#### **Addendum 128 – UN Regulation No. 129**

#### **Revision 4 - Amendment 3**

Supplement 3 to the 03 series of amendments – Date of entry into force: 29 May 2020

#### **Uniform provisions concerning the approval of Enhanced Child Restraint Systems used on board of motor vehicles (ECRS)**

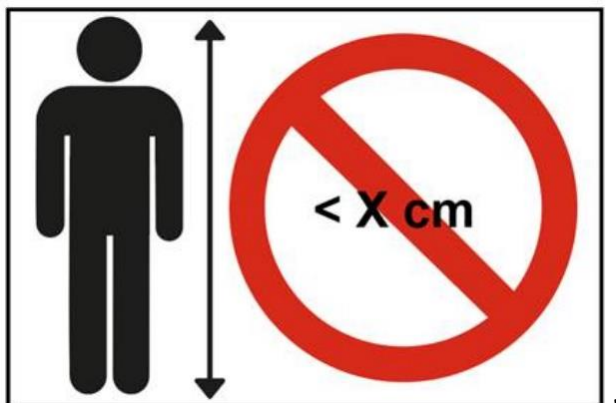
- "4.8.3. Universal booster cushion Enhanced Child Restraint Systems shall have a permanently attached label with the following information visible to the person installing the Enhanced Child Restraint System in the car:

Universal booster cushion

- 4.8.4. Specific vehicle booster cushion Enhanced Child Restraint Systems (except built-in) shall have a permanently attached label with the following information visible to the person installing the Enhanced Child Restraint System in the car:

Specific vehicle booster cushion

- 4.8.5. Booster cushion Enhanced Child Restraint Systems shall have the following label (Minimum size: 60 x 40 mm) permanently attached and visible to the person installing the Enhanced Child Restraint System in the car. The limit X shown on the label represents the lower stature of the size range the Enhanced Child Restraint System is approved to. If the booster cushion is approved in combination with a booster seat the label shall be visible only when the ECRS is used as a booster cushion.

Figure 1  
Measurement device to check the Sitting Height

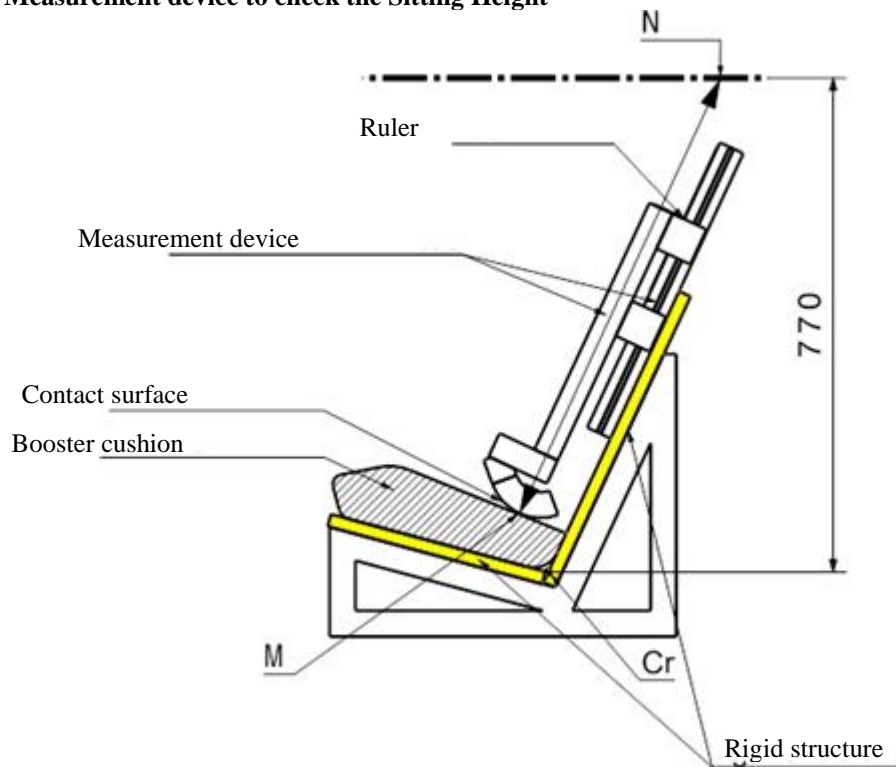
"6.1.3.6. For booster cushions, type approval shall not be granted for a stature below 125 cm. Booster cushions shall not be declared for use below a stature of 125 cm.

Booster cushions shall ensure that the top of the child's head is at or above a horizontal plane at 770 mm vertically from the Cr axis when seated on the test bench described in Annex 6.

The procedure to check if a booster cushion fulfils this requirement is outlined as follows (See Figure 1 below):

- (a) A simulated test bench shall be used for the assessment. The simulated bench shall have the same geometry as the test bench defined in Annex 6 of this Regulation, including the seat cushions. However, the width of the simulated bench may be reduced, if the width is between 500 and 800 mm, as shown in Annex 25. The simulated test bench shall be of rigid construction and shall not deform when using the measuring device defined in Annex 25.

- (b) A rigid structure is attached to the simulated test bench and holds a sliding part. A horizontal plane that is located at a vertical distance of 770 mm from the Cr axis is defined.

- (c) The booster cushion shall be placed on the simulated test bench with its centreline aligned with the centreline of the test bench and the rear surface of the booster cushion contacting the backrest of the test bench.

- (d) If ISOFIX attachments are present these shall be latched with the test bench lower ISOFIX anchorages. An additional force of 135 +/-15N shall be applied in a plane parallel to the surface of the simulated test bench. The force shall be applied along the centreline of the Enhanced Child Restraint System and at a height of no more than 100 mm above the simulated test bench seat surface.

- (e) The measurement device is extended downwards parallel to the simulated test bench backrest, until it is stopped by the booster seat cushion.

Figure 2  
**Ruler of measurement device**

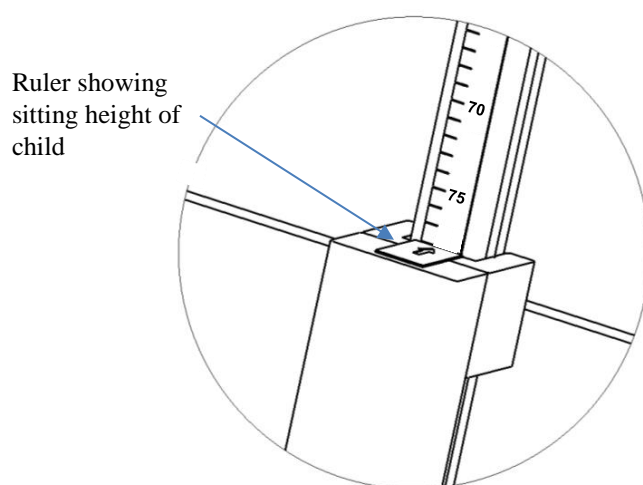
- (f) The measured distance between the two points M and N (Figure 1) represents the sitting height of a child who will use the booster cushion. The corresponding value is displayed by a ruler that is provided with the device as shown in Figure 2.

- (g) Using the data in Table 3, the sitting height is utilized to determine the corresponding minimum stature of the child that can be accommodated by the booster cushion. Example: A sitting height of 66.2 cm shall correspond to a child minimum stature of 125 cm; a sitting height of 75.9 cm shall correspond to 150 cm.

- In case the value obtained for the sitting height is between two integer values always round up to the next integer value (e.g. Measured sitting height = 70.1 cm ► resulting stature = 135.65 cm ► Smallest stature allowed = 136 cm).

- (h) The stature determined in this procedure shall be compared to the lower limit of the approval stature range. The requirement is fulfilled if the lower approval stature is greater or equal than the obtained minimum stature.

### 1. Arrangements of the approval mark

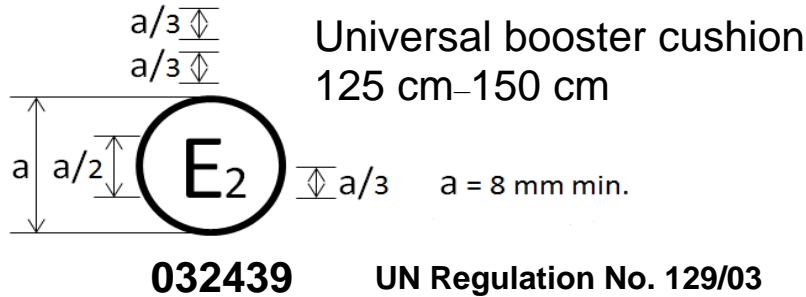
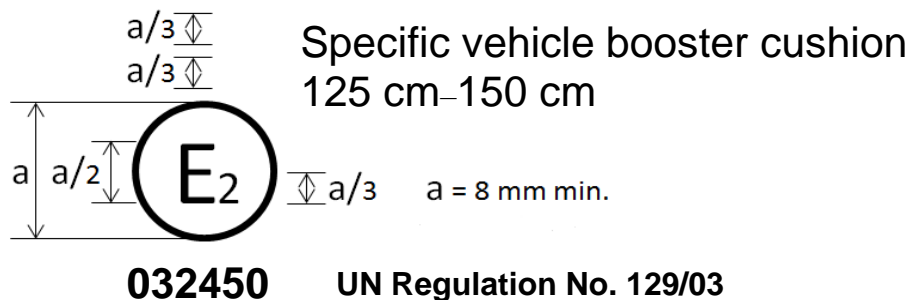
The Enhanced Child Restraint System bearing the above approval mark can be fitted in any i-Size seating position and Universal seating position, and used for the 125 cm–150 cm size range; it is approved in France (E 2) under the number 032439. The approval number indicates that the approval was granted in accordance with the requirements of the Regulation concerning the approval of Enhanced Child Restraint Systems used on-board of motor vehicles as amended by the 03 series of amendments. In addition, the name of the Regulation is to be identified on the approval mark followed by the series of amendment according to which the approval has been granted.

The Enhanced Child Restraint System bearing the above approval mark is a device not capable of being fitted in every vehicle but is capable of being used for the 125 cm–150 cm size range; it is approved in France (E 2) under the number 032450. The approval number indicates that the approval was granted in accordance with the requirements of the Regulation concerning the approval of specific vehicle booster cushion Enhanced Child Restraint Systems used on-board of motor vehicles as amended by the 03 series of amendments. In addition, the name of the Regulation needs to be identified on the approval mark followed by the series of amendment according to which the approval has been granted.

**Device to measure the booster cushion height**

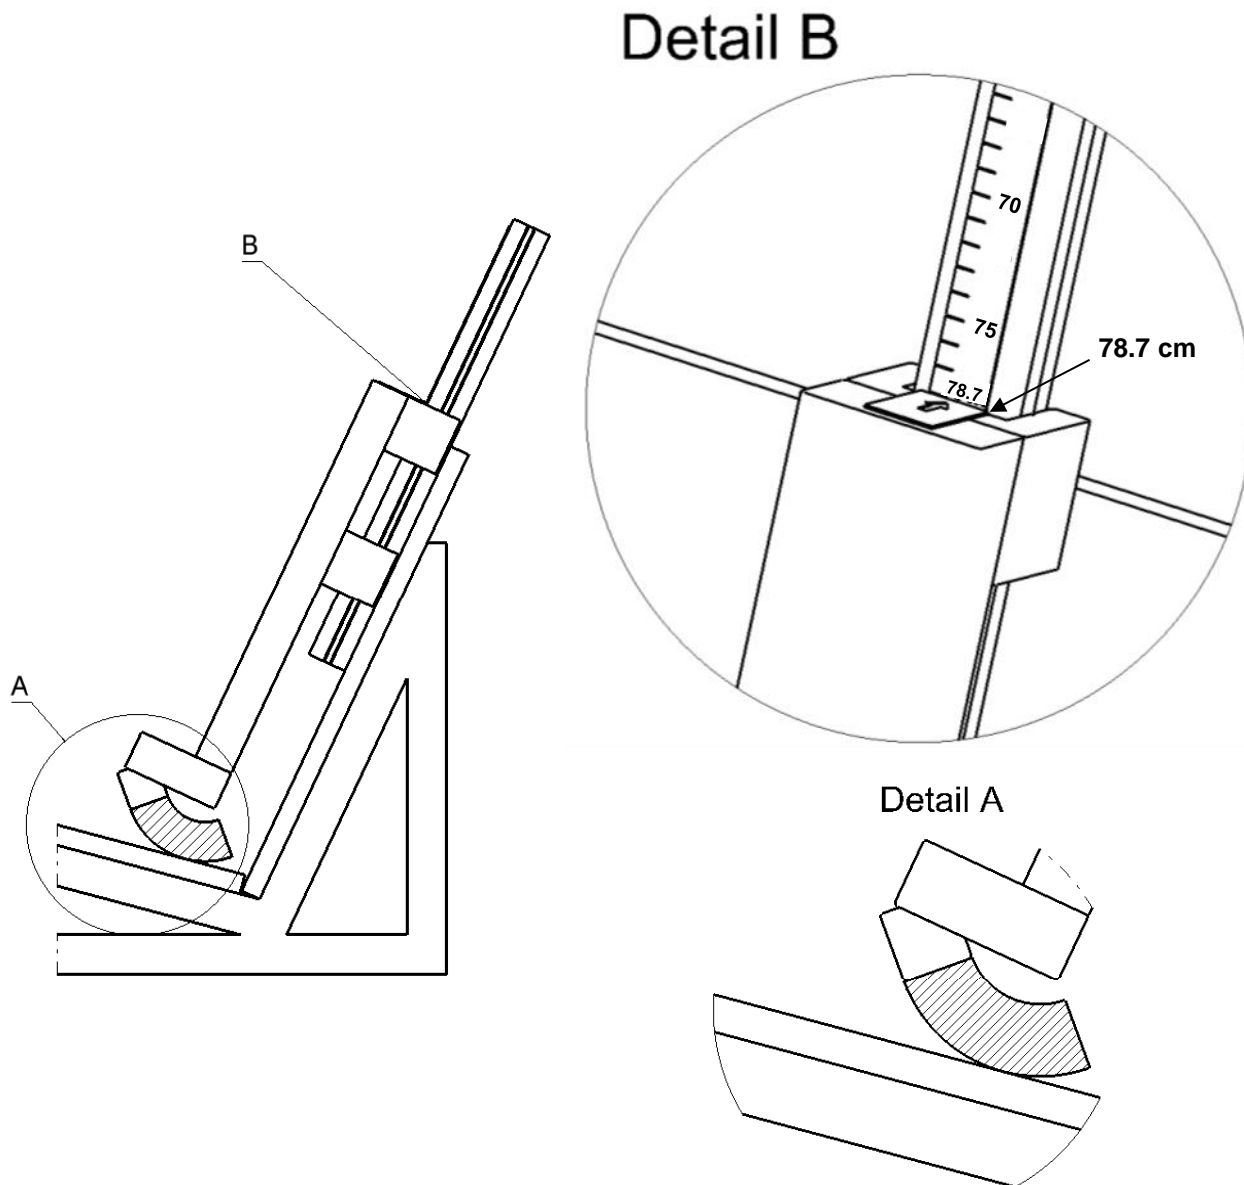
The mass of the device shall be 15kg +/-1kg

To calibrate the ruler of the measurement device, its structure shall contact the supporting surface (Detail A). In this configuration, the scale shall show the calibration value of 78.7 cm (Detail B).

The calibration of the ruler is based on the sitting height of the Hybrid III 5th percentile dummy seated on the test bench defined in Annex 6 of this Regulation. When this dummy is seated on the test bench, the top of the head is 77.0 cm from the Cr axis. The nominal sitting height of the dummy is 78.7 cm. Therefore, 78.7 cm is used as the calibration value.

**Manikin block (based on truncated P10)**

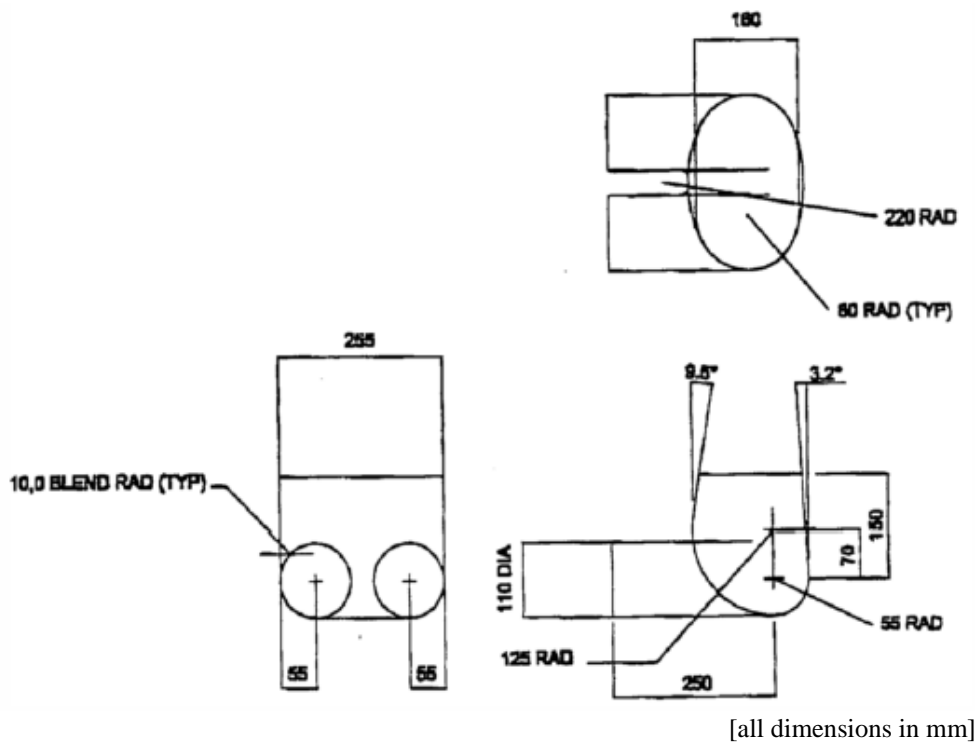
Place a cotton cloth on the seating surface of the test bench. Position the booster cushion on the test bench, position the lower torso body block as described in Annex 26, Figure 1, on the seating surface, fit and apply the 3-point adult safety-belt and tension as prescribed in paragraph 7.1.3.5.2.2. With a strip of 25 mm-wide webbing or similar, tied around the booster, apply a load of  $250 \pm 5$  N in the direction of arrow A (see Annex 26, Figure 2), in line with the seating surface of the test bench.

**Material:** Expanded polystyrene (EPS) (40 to 45 g/l) or alternative non-deformable material

**Booster pull test using manikin block**

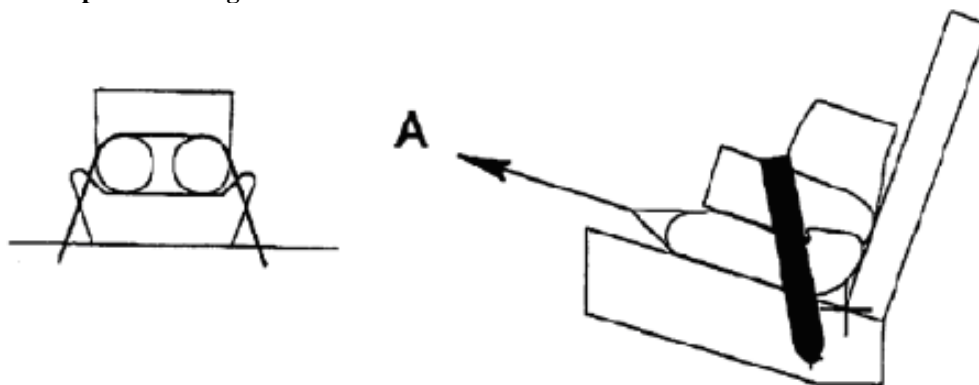
The booster cushion shall not be pulled completely out of the 3-point adult safety-belt and shall remain under the body block during the test."
